## Town of Arlington, MA Redevelopment Board

## Agenda & Meeting Notice May 18, 2020

## Docket #2818, 880 Massachusetts Avenue \*Continued Public Hearing\*

Board will continue hearing for Special Permit Docket #3602 to review application by James F. Doherty for 1211 Mass Ave Realty Trust, at 1207-1211 Massachusetts Avenue, Arlington, MA, 02476, to construct a 50-room hotel and restaurant at 1207-1211 Massachusetts Avenue in the B2 Neighborhood Business District and B4 Vehicular Oriented Business District. The continuation of the hearing is to allow the Board to review and approve the application in accordance with the provisions of MGL Chapter 40A and the Town of Arlington Zoning Bylaw Section 3.4, Environmental Design Review.

SHADOW STYDY/SPRING EQUINOX

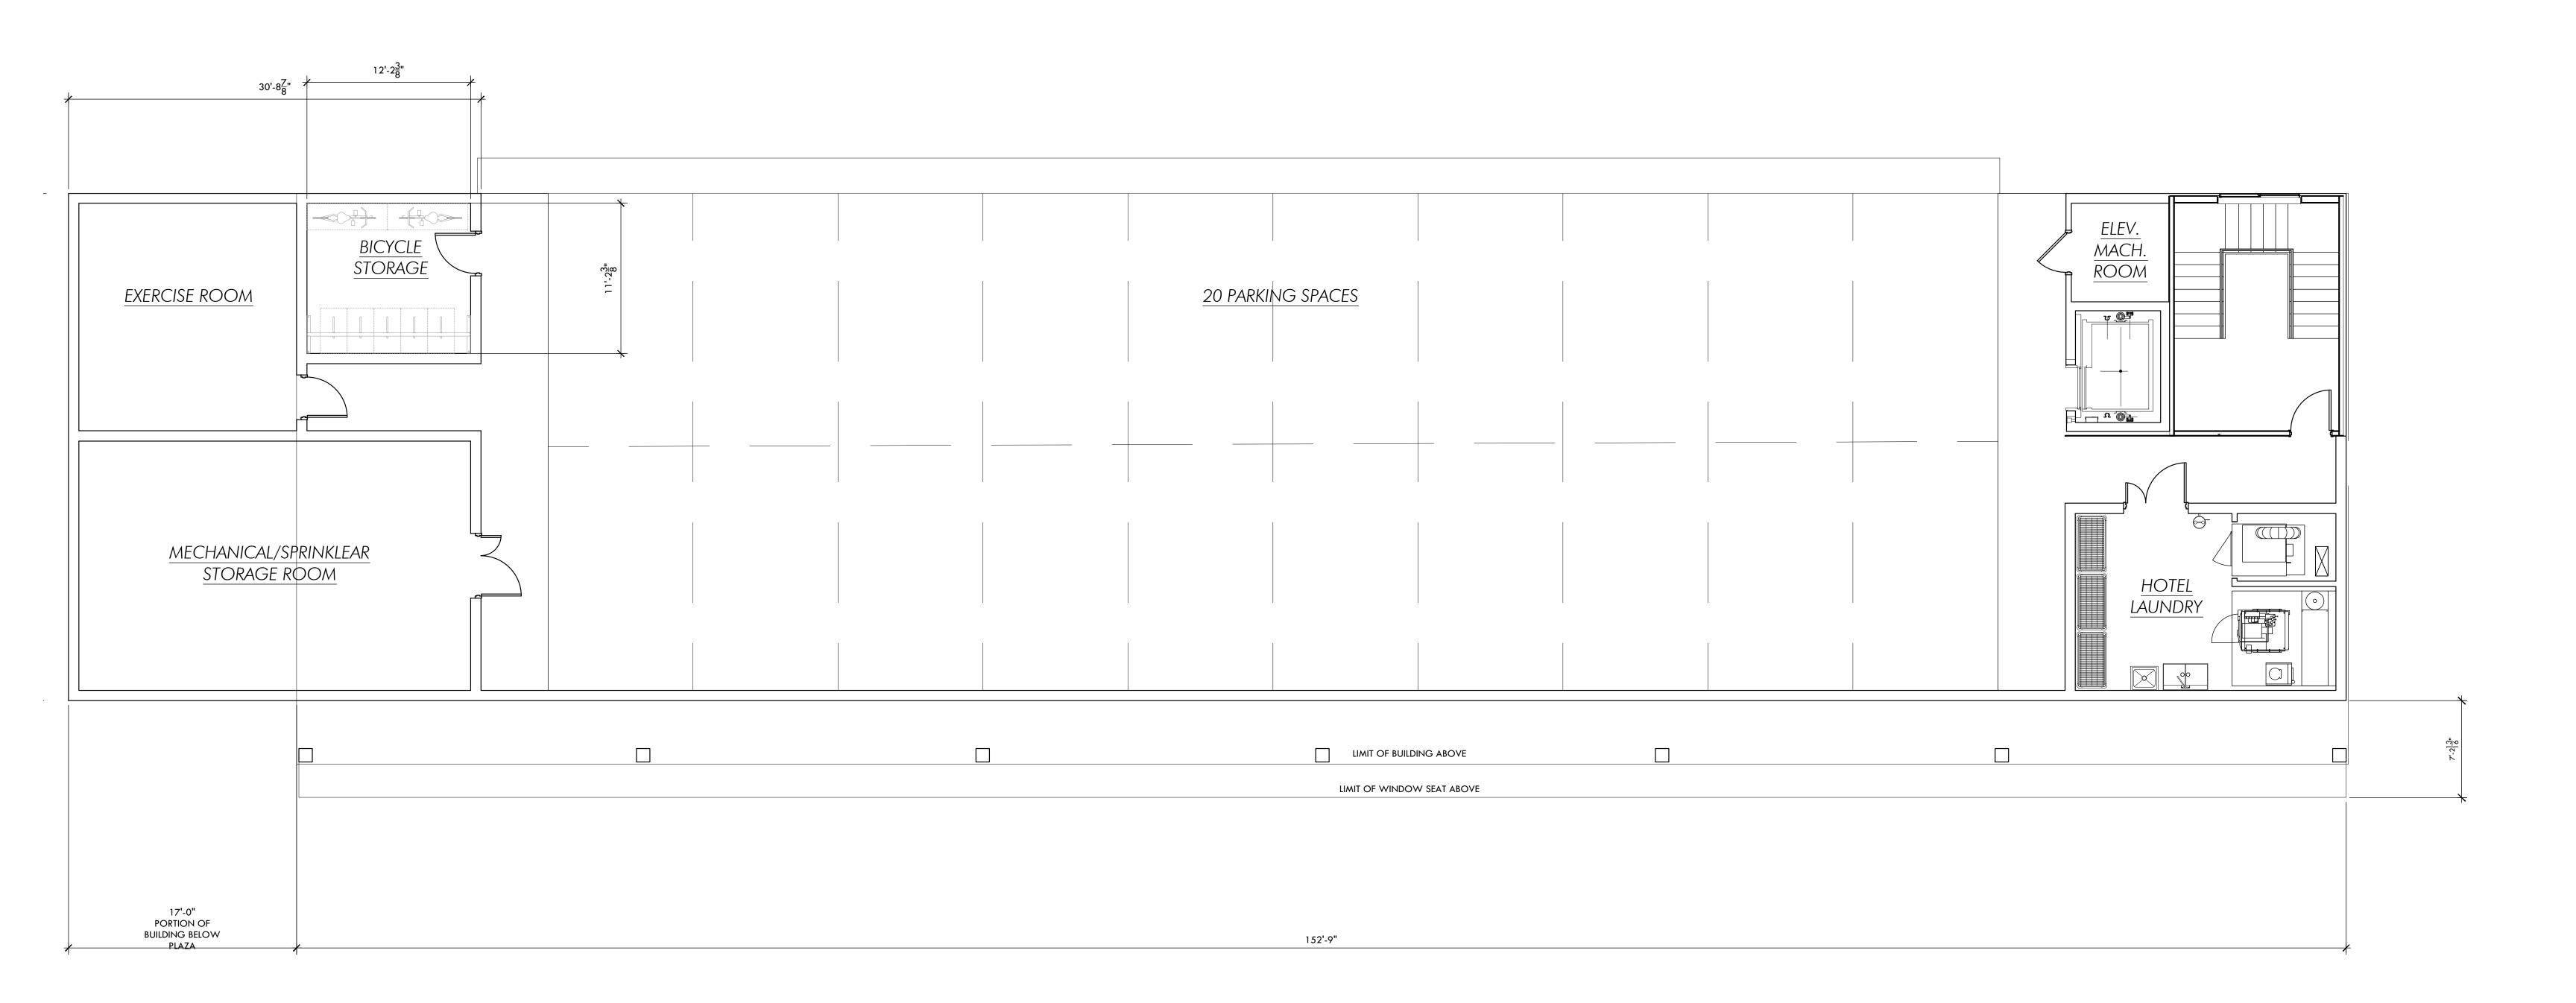
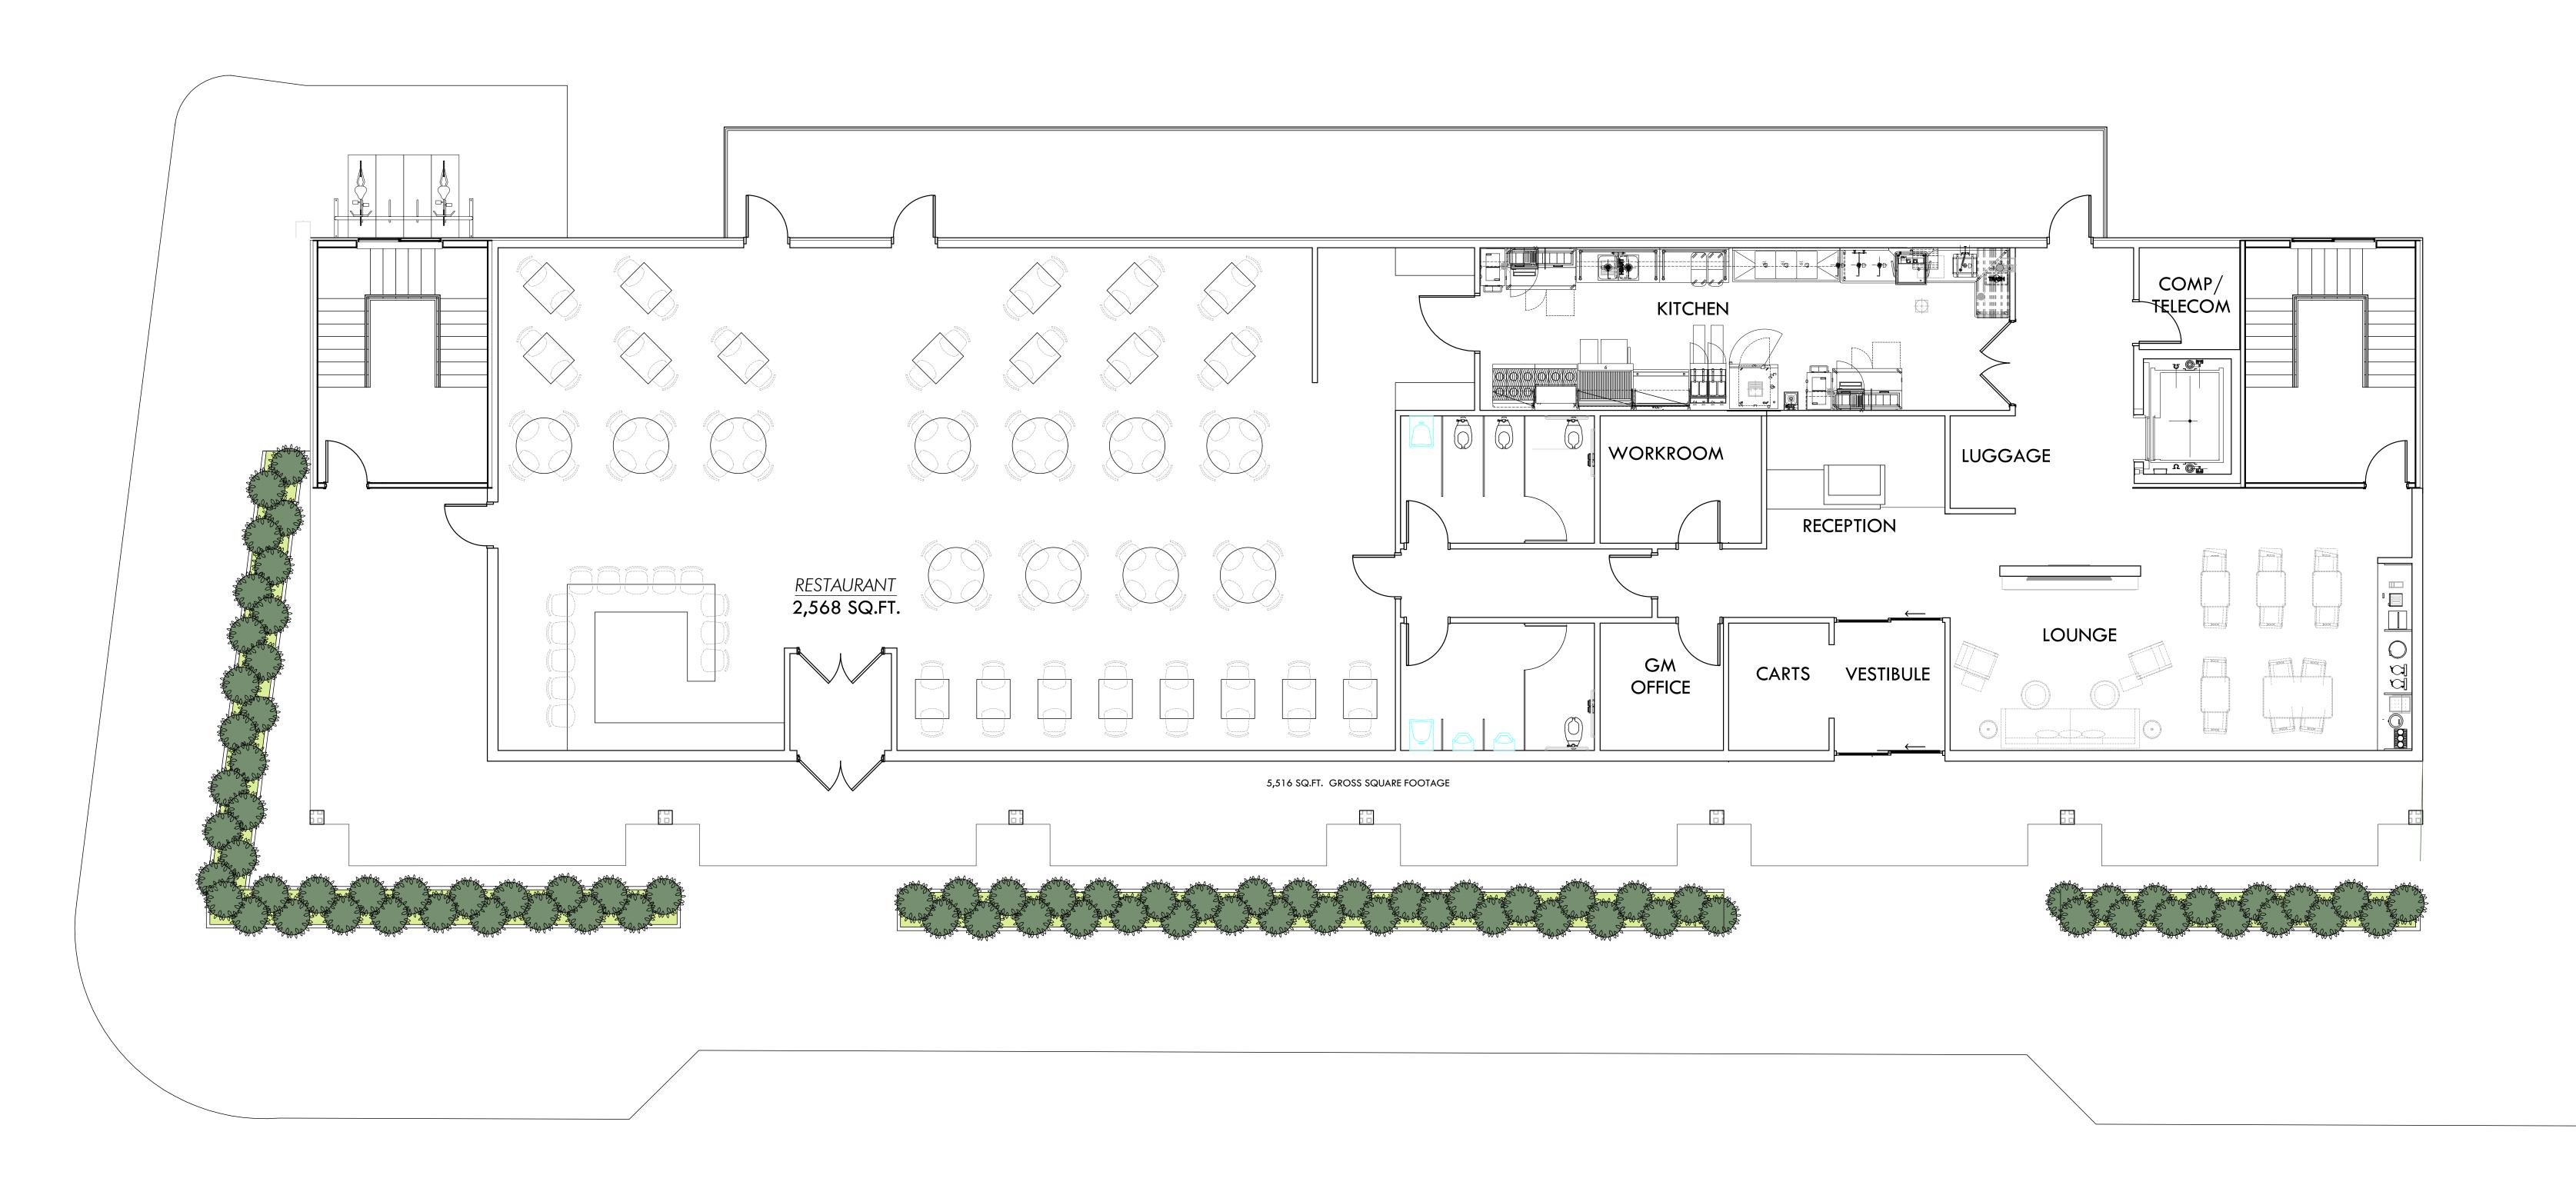
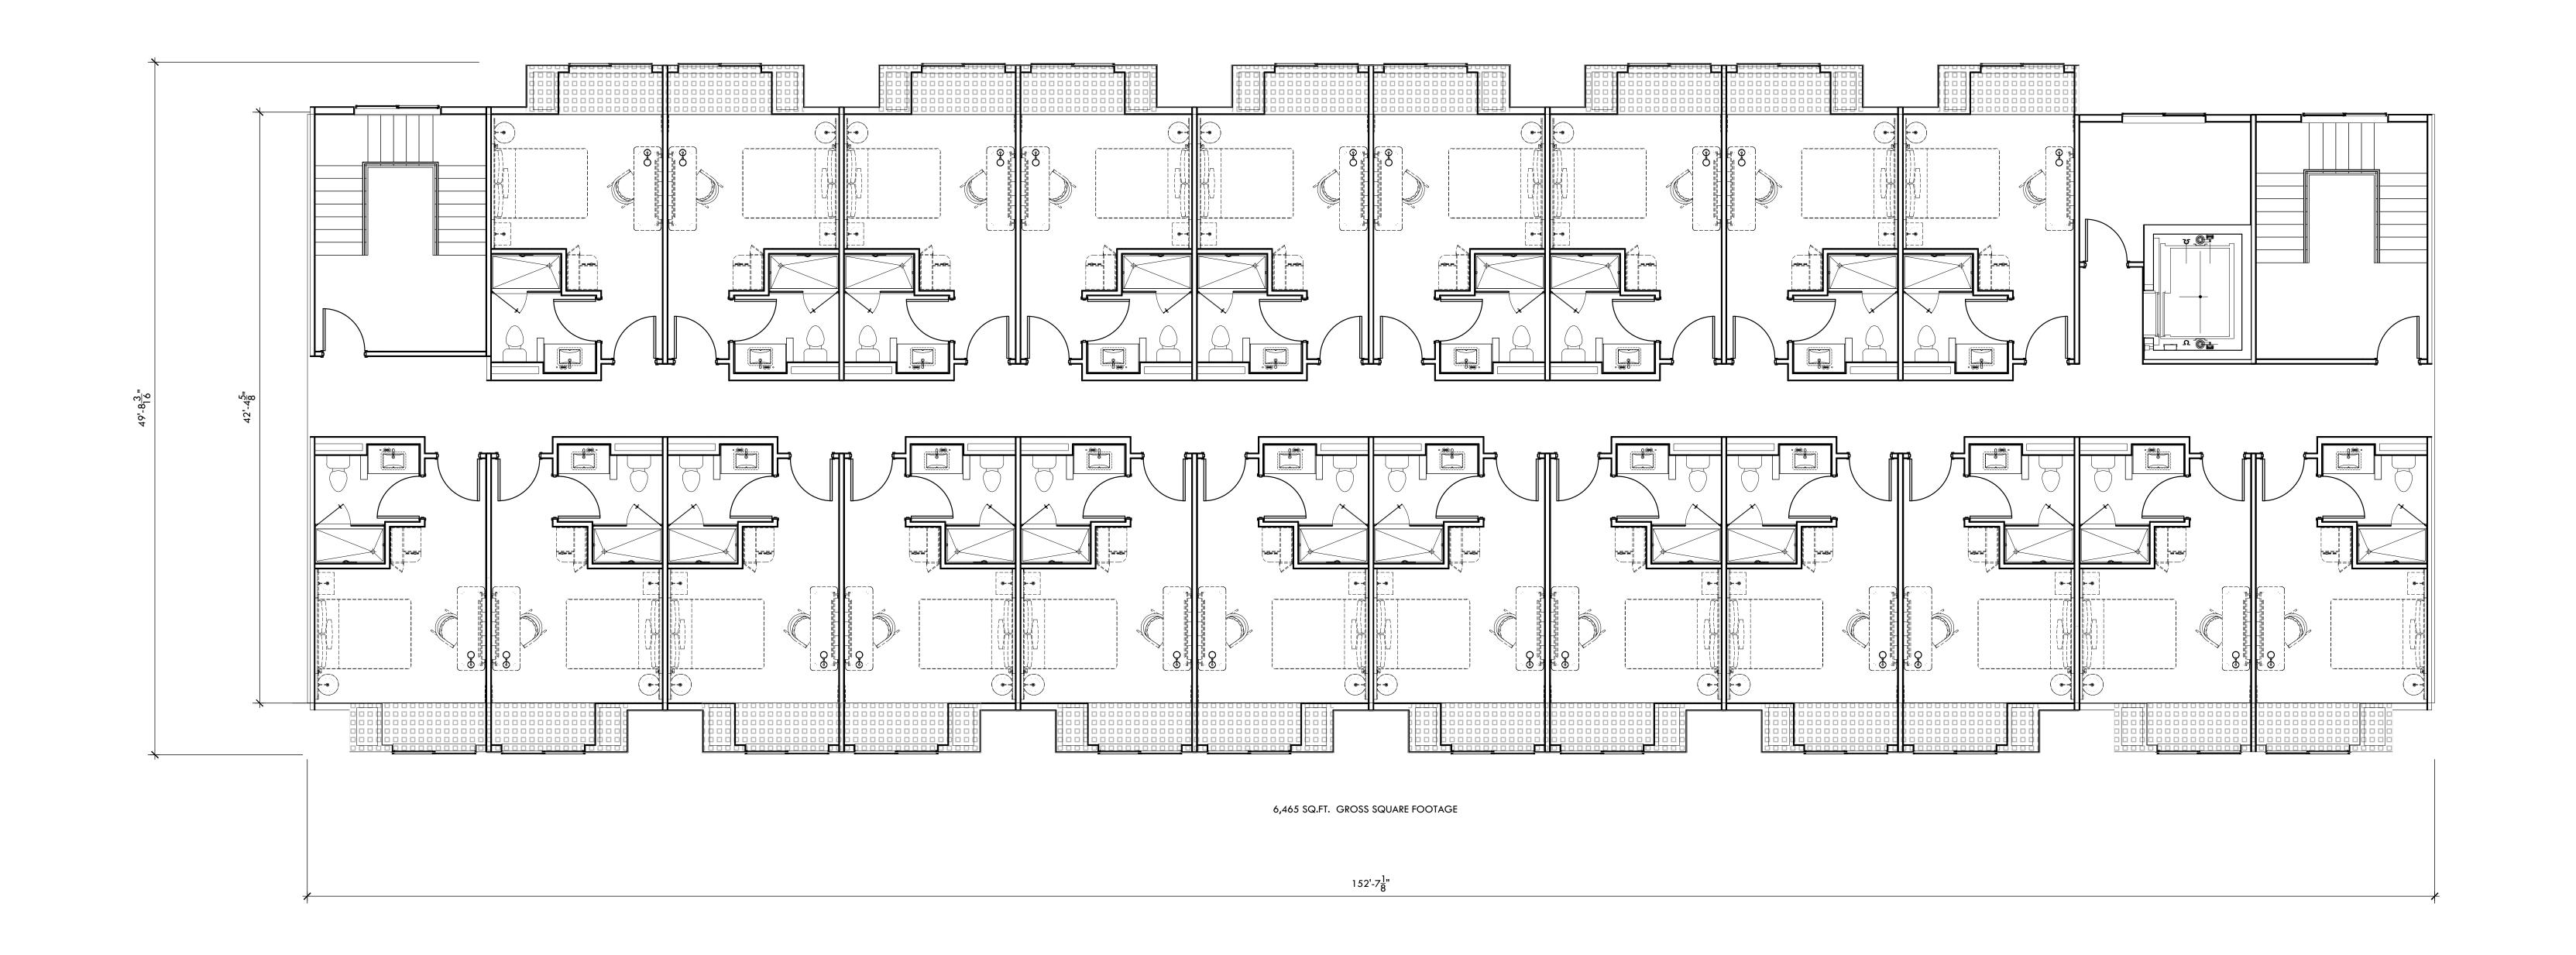
7. Re-evaluate the shadow study previously submitted to consider the existing shadows and provide a comparison and determine any impact to solar arrays in the neighborhood.

7. Take another look at your shadow study, consider the existing shadows and provide a comparison and determine any impact to solar arrays in the neighborhood;

The plan set includes an updated shadow study based on the new building. The plan set also includes a shadow study documenting the existing conditions of the building and shows trees at the rear of the site.

The plan set includes an updated shadow study based on the new building. The plan set also includes a shadow study documenting the existing conditions of the building and shows trees at the rear of the site. The updated materials do not identify if any of the adjacent buildings have solar arrays installed.
